## NON-CONCURRENCE PROCESS COVER PAGE

2. Title of Subject Document Draft Regulatory Guide DG-1363, Proposed Revision 4 to Regulatory Guide 1.105, "Setpoints for Safety-Related Service"	3. ADAMS Accession Number ML20009d873
---	--

**DG-1141 Figure 2: *Trippoint Probability Distribution***

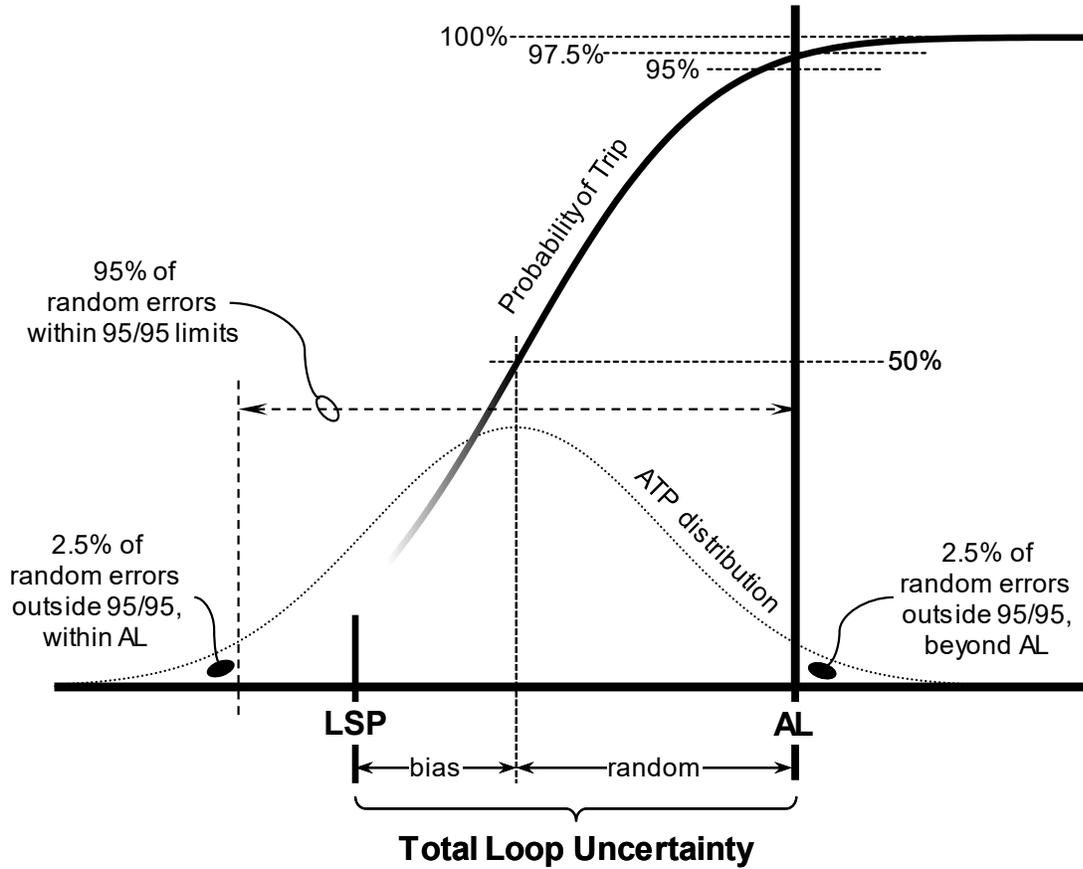
The standard explicitly accepts a 5% probability that the analytical limit for a channel will be exceeded (final sentence in Section 4.3, on page 15). DG-1141 showed that the 95/95 criterion, together with an assumption that trippoint errors are normally distributed, results in a 2½% probability that the analytical limit will be exceeded (DG-1141 Figure 2, and associated text -- DG-1141 Figure 2 is attached to this form for reference).

DG-1141 Figure 2 shows a Gaussian distribution of Actual Trippoints (ATP), such as might typically be expected for a single trip channel, along with the associated Limiting Setpoint (LSP), Analytical Limit (AL), allowances for random and bias uncertainties, and associated probabilities. Revision 2 of RG 1.105, issued in February of 1986, introduced criteria similar to the 95/95 criterion upon which Figure 2 is based. In particular, the Rev2 criterion specifically references the “±2 sigma” band (more accurately, ±1.96 sigma) typically associated with 95/95 and symmetrically

disposed about the mean. Revision 3 further refines these criteria with specific reference to 95/95. Figure 2 therefore presents considerations tacitly recommended by the NRC for decades. Thus, the acceptable limit on the probability for a nonconservative trippoint has been tacitly established by the NRC in past revisions to RG1.105 to be 2½%.

The increase in the probability of nonconservative operation in a single channel from 2½% to 5% has been shown to result in a more than seven-fold increase in the likelihood that a safety function that employs 2/4 voting will fail to be initiated in accordance with the corresponding safety analysis, resulting in operation in an unanalyzed condition. This analysis is presented in the document identified as "95/95 and Single-Sided Setpoints," ML19239A261. The analysis is marked "DRAFT" only because it has not been formally reviewed and accepted. It is complete, and informal reviews have not resulted in any statement of concern.

The overt acceptance of a 5% probability of nonconservative operation also introduces an additional problem: The question of "Single-Sided Setpoints" (SSS -- this 5% vs 2½% question) has been debated for a long time, with strong opinions both in favor of their acceptance and opposing them. It was a major point of contention in the development of DG-1141. The designation itself is a misnomer, sometimes confused with one-sided vs two-sided statistical considerations such as discussed in section 9.6 of NUREG-1475, the NRC's Statistical text developed by Dan Lurie *et al.* I believe the term derives from the concept of lumping the entire 5% of ATP that fall outside the 95/95 boundaries to the nonconservative side of the mean, as opposed to the symmetrical distribution shown in the attached figure.

Where DG-1141 proposed a recommended placement of the tolerance interval such that 2.5% of the sample standard probability distribution may be allowed to exceed the analytical limit (i.e., 97.5% of the distribution to be maintained on the conservative side of the analytical limit), the Committee chose to standardize on 5% of the probability distribution exceeding the analytical limit. (The 2018 ISA standard includes the statement: “The chosen setpoint should be a value that represents the performance of the instrumentation, with a 95% probability of channel trip at or before the analytical limit is reached at a 95% confidence level.”) The consensus of the Committee members was that this placement was adequate to enable users of the standard to achieve significant conservatism in establishing sufficient margin to safety to allow for channel inaccuracies and channel drift occurring between successive surveillance intervals. The Committee considered that it is extremely unlikely for all the individual performance uncertainty terms included within the total channel uncertainty estimate to be simultaneously present within the tails of the population distribution, even under accident conditions. The Committee also noted that previous versions of RG 1.105 provided guidance for making bounding estimates of the uncertainty at a 95/95 probability/confidence level, but until the issuance of DG-1141, the RG had never specified what portion of the total instrument channel uncertainty probability distribution needed to be maintained on the non-conservative side of the analytical limit.

The Committee also observed that many existing licensee setpoint methodologies have implemented the 95% placement of the tolerance interval, and that operating experience gained since the late 1990s, indicates this methodology appears to be both safe and practical. Standardizing on a requirement for ensuring 97.5% of the population probability distribution data to be maintained on the conservative side of the analytical limit was deemed by the Committee to be overly conservative and not consistently achievable for a large segment of the nuclear industry. The Committee preferred the 95% approach as a pragmatic one, because some plants have a more limited margin available (requiring a more rigid approach that Mr. Rebstock had a significant amount of experience with), and some have a larger margins between the analytical limit and setpoint. This difference is what led to the difficulty in agreeing on this issue in the standard itself for many years before the development of the 2018 version.

The cognizant NRC staff other than Mr. Rebstock recognize that his recommended 97.5% does result in a more conservative placement of the limiting setpoint than does 95%, but they also recognize that licensees need to be practical in applying this larger allocation to minimize the likelihood of spurious actuations of safety channels when the normal process variation excursions encroach upon the channel setpoint when no actual adverse condition has occurred. In practice, staff reviewers of proposed new Technical Specification-related instrument channel setpoints and allowable values use risk insights based on an examination of existing margin between analytical limits and nominal setpoints before performing an evaluation of the proposed instrument channel uncertainty margin in detail. This use of risk insights helps to inform staff reviewers as to the effectiveness of the degree of conservatism that has been applied by applicants and licensees.
